Re: CC Docket No. 92-297, RM-7872, RM 7722
Ex Parte Presentation

Review of GeoWave Proposal for the Co-Frequency Sharing of the 28 GHz Band by the Local Multipoint Distribution Service (LMDS) and the Fixed Satellite Service (FSS)

Summary

Figure 4: Possible Interference Components on an LMDS Cell Located at the Border of 4 Teledesic Cells

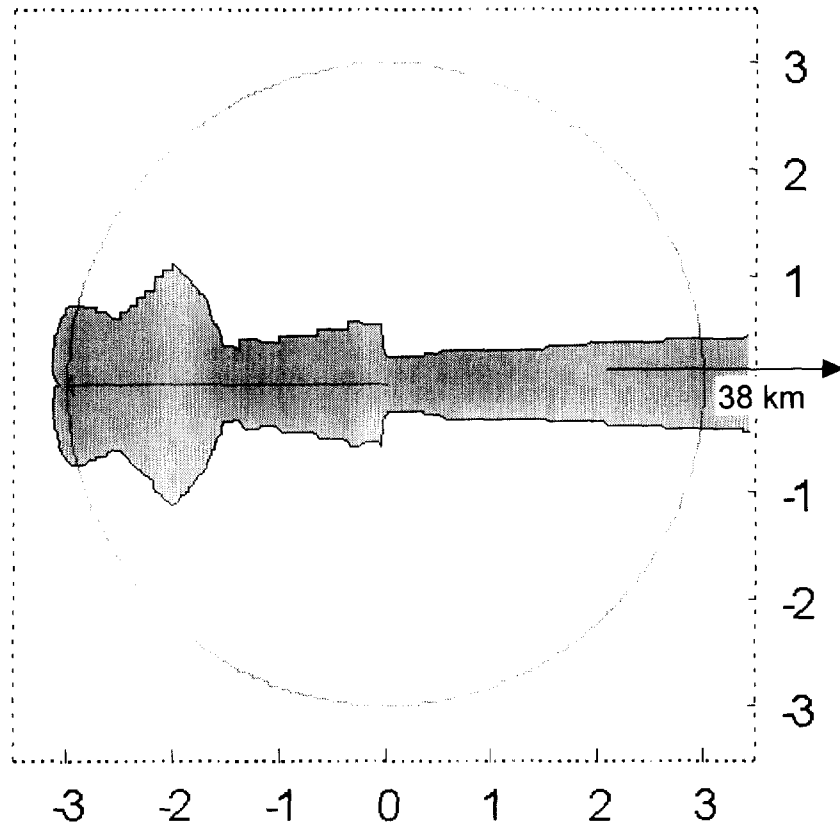
2. The GeoWave proposal neglects the fact (although this fact is clearly demonstrated in slide 7 of their presentation) that an LMDS cell might overlap with as many as four adjacent Teledesic cells as shown in Figure 4. In that case, those LMDS cells will be de-activated 44.4% of the time (=4/9) rather than just 11.1% (=1/9) of the time as GeoWave claims. The LMDS

utilizes an omni-directional antenna at their hub, so deactivating an LMDS cell means that all LMDS subscribers in that cell will be denied service.

Figure 1 Interference from TST into LMDS hub to subscriber link. The LMDS subscriber is located at cell edge pointing to the hub at cell center. The subscriber will experience unacceptable interference if a single TST is operating in the shaded area.

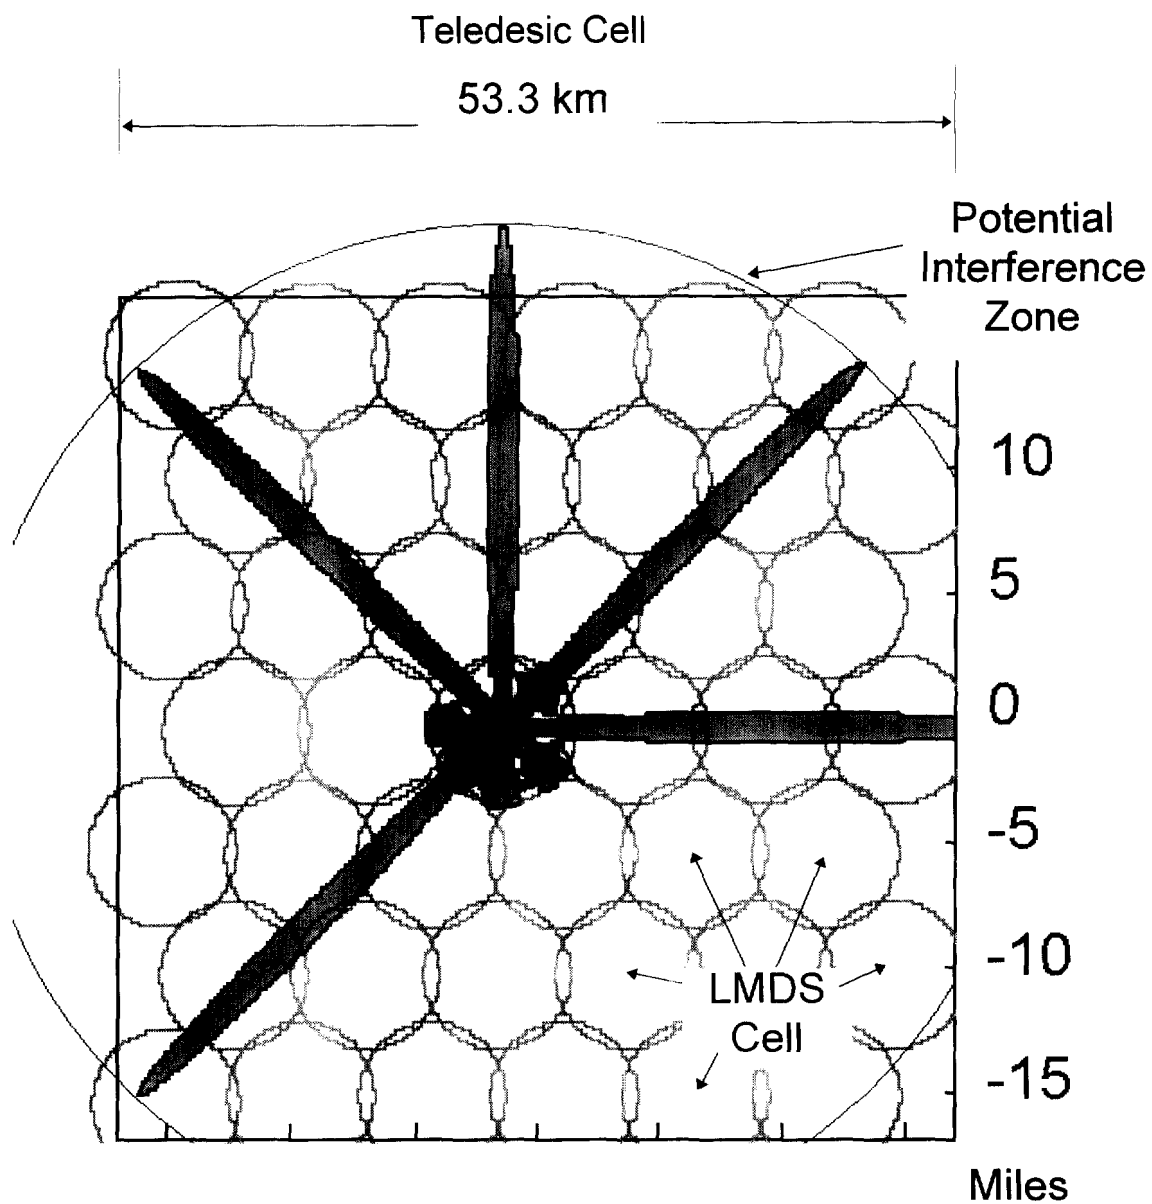
1. GeoWave completely neglects the effect of adjacent cell interference. A detailed analysis submitted by Teledesic Corporation to the NRMCC in 1994, clearly indicated that the transmission from TSTs located in an illuminated Teledesic cell will cause interference to LMDS subscribers located in adjacent cells.

In Figure 1, an LMDS subscriber is placed on the edge of the LMDS cell and is pointing toward the center of the cell where the LMDS hub is located. The enclosed area which includes the antenna boresights between the subscriber and the hub indicate the region where a TST can not operate without causing the carrier to interference ratio (C/I) at the LMDS subscriber to dip below the minimum acceptable value. It was shown in [1] that the minimum clearance distance, measured from the boresight, is 38.1 km (23.7 miles).

Figure 2 Interference from TST into LMDS hub to subscriber link. The potential interference zone indicates that a TST may interfere with LMDS subscribers in more than 4 LMDS cells. An LMDS subscriber may experience unacceptable interference even if a TST is 38 km away.

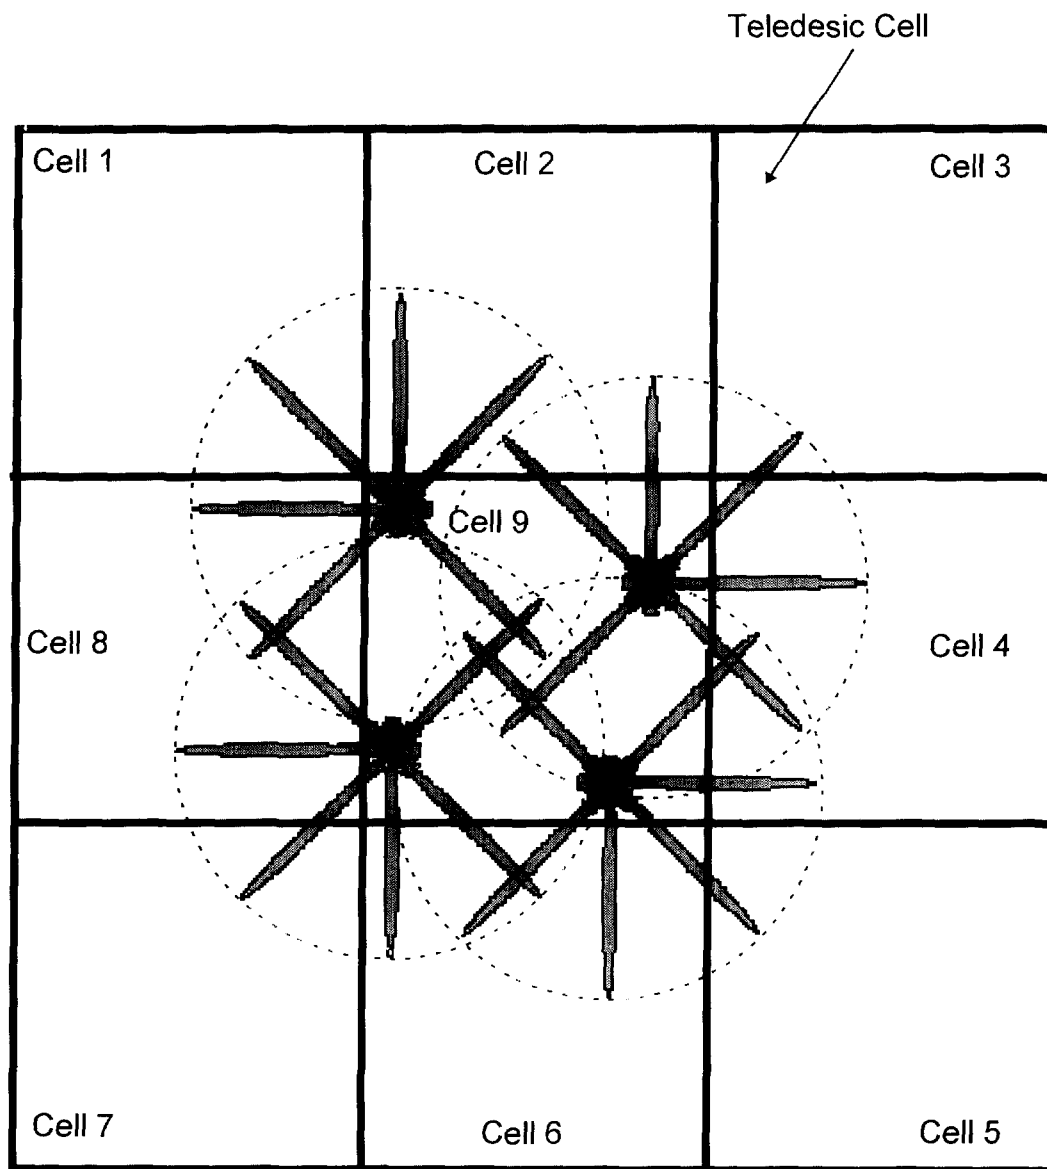
In Figure 2, five LMDS subscribers were located at random on the edge of an LMDS cell located at the center of a Teledesic cell. The TSTs can not be located in the shaded areas without causing an unacceptable interference into those LMDS subscribers. As the number of LMDS subscribers located at the edge of that LMDS cell increases, the shaded areas would increase and a circle of radius 38.1 km, centered around the LMDS hub, would result, in which TSTs can not be located. This is referred to as the "potential interference zone" in Figure 2.

Figure 3 The Potential interference zones is a circle with a radius about 38 km. Any TSTs located within Teledesic cell 1 through cell 9 may interfere with LMDS subscribers located in cell 9.

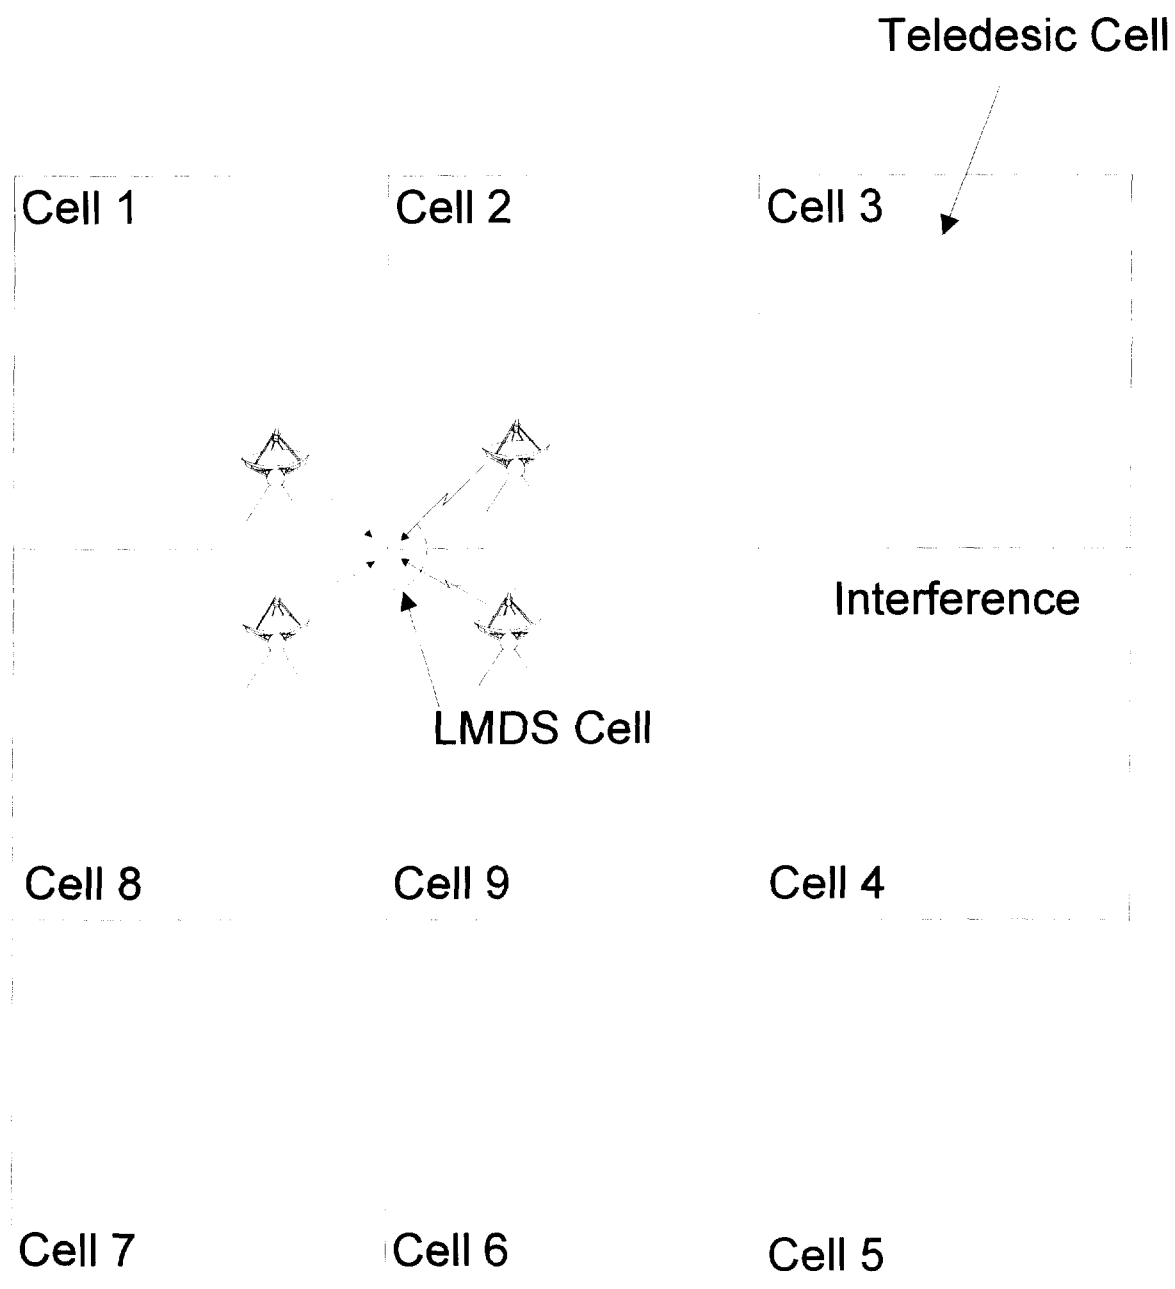
In Figure 3, four LMDS cells are located near the boundaries of a Teledesic cell. It is clear that the potential interference zones extend beyond the boundaries of that particular Teledesic cell. For example, during the time Teledesic cell number 6 is illuminated, some TSTs located in that cell will cause an unacceptable interference into the LMDS subscribers that are located in some LMDS cells in Teledesic cell number 9. Hence, the statement made by GeoWave Corporation that LMDS systems will be operating in an interference-free environment 89% (=8/9) of the time is completely invalid.
